Office Action Summary

10/696,757

INFLATABLE AIRBAG AND METHOD OF MAKING THE SAME
SOLLARS

FIG. -5-

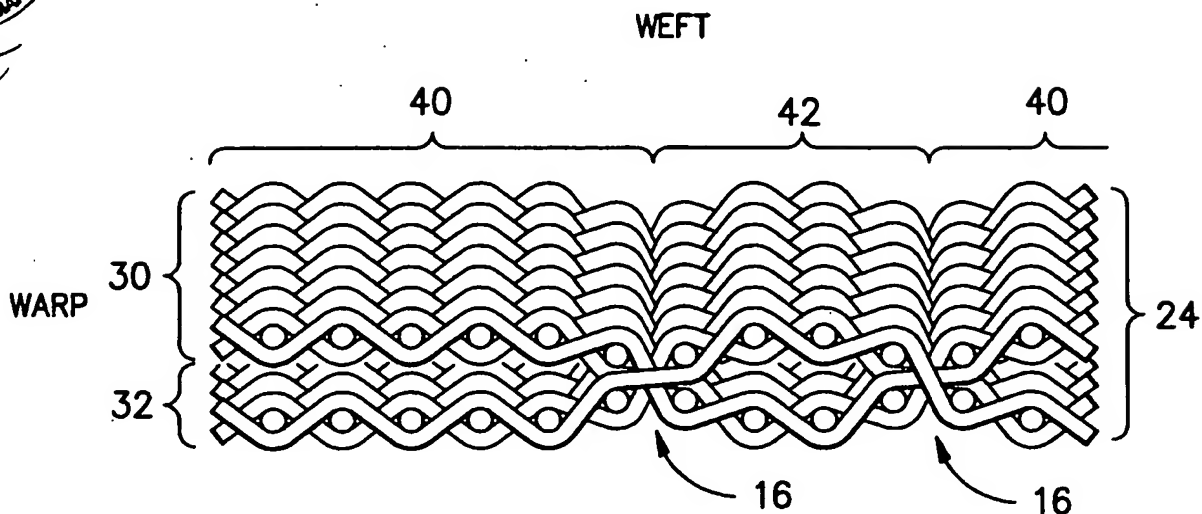
Entry Not
Approved
EC
11/22/05
